## **NORTHERN BEACHES LOCAL PLANNING PANEL MEETING**

**WEDNESDAY 20 MAY 2020**

ITEM 3.1	DA2019/1340 - LOT 100/ MEATWORKS AVENUE, OXFORD FALLS - ALTERATIONS AND ADDITIONS TO THE EXISTING PREMISES
AUTHORISING MANAGER	STEVE FINDLAY
TRIM FILE REF	2020/274643
ATTACHMENTS	<ol style="list-style-type: none"><li>1 Assessment Report</li><li>2 Minutes - Independent Public Hearing Panel</li><li>3 Site Plan and Elevations</li></ol>

## DEVELOPMENT APPLICATION ASSESSMENT REPORT

**Figure 7: View of Non-compliant Building Height** (Plans as prepared by Gelder Architects, dated 15 November 2019, with extent of non-compliance added in red)

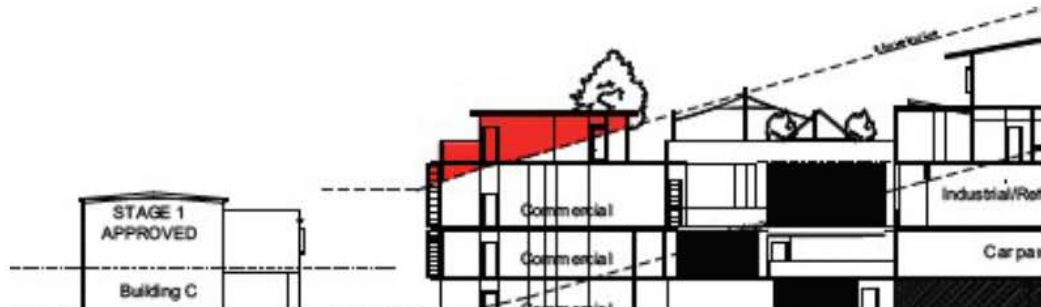
The proposed building has a variable height above ground level of between 7.5m along its southern edge up to a maximum of 11.5m measured to the roof of the ancillary facilities/service hub. The proposal also exceeds the 7.2 metre wall height control.

Figure: The extent of the height of building breach (shown in yellow and circled in red).

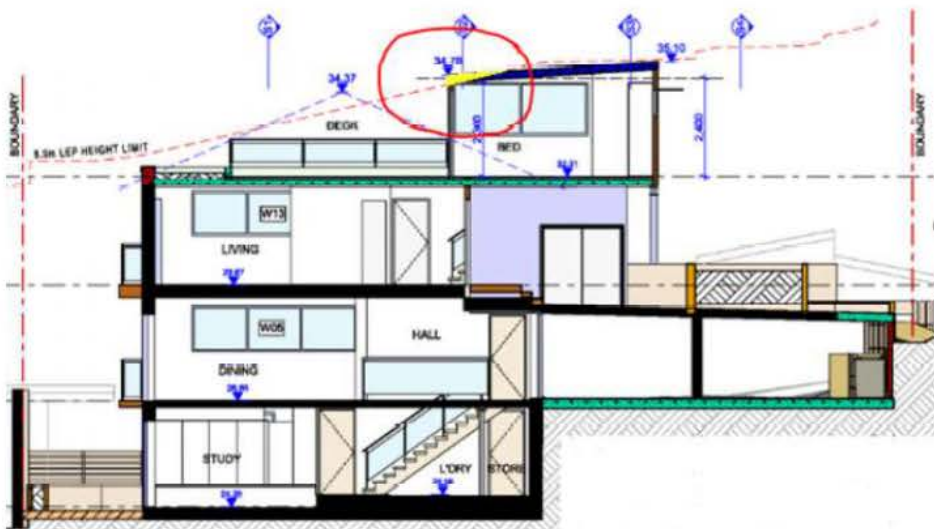
Development standard:	Height of Buildings
Requirement:	8.5m
Proposed:	8.7m
Percentage variation to requirement:	2.35%
